EOL Announcement

Due to force majeure factors such as chips and raw materials supply discontinuation, and to achieve unified management of product models and styles, 3onedata announces the end-of-sale and end-of-life dates for the SW485GI V1.0.0 series interface converter.

Table 3: Appearance of the SW485GI V1.0.0 (left) and SW485GI V2.0.0 (right)

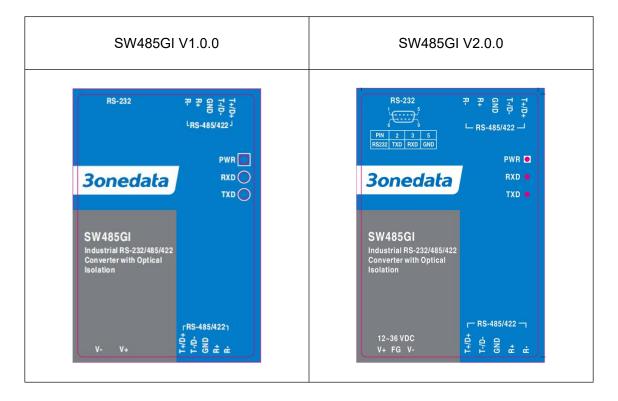
Differences between SW485GI V1.0.0 and SW485GI V2.0.0 are as follows:

1. Operating temperature

SW485GI V1.0.0 support -10~75 $^{\circ}$ C wide operating temperature range, while SW485GI V2.0.0 support -40~75 $^{\circ}$ C operating temperature range.

2. Appearance

SW485GI V2.0.0 has specific description of the signal pins of the RS-232 DB9 interface and description of input range of power supply.
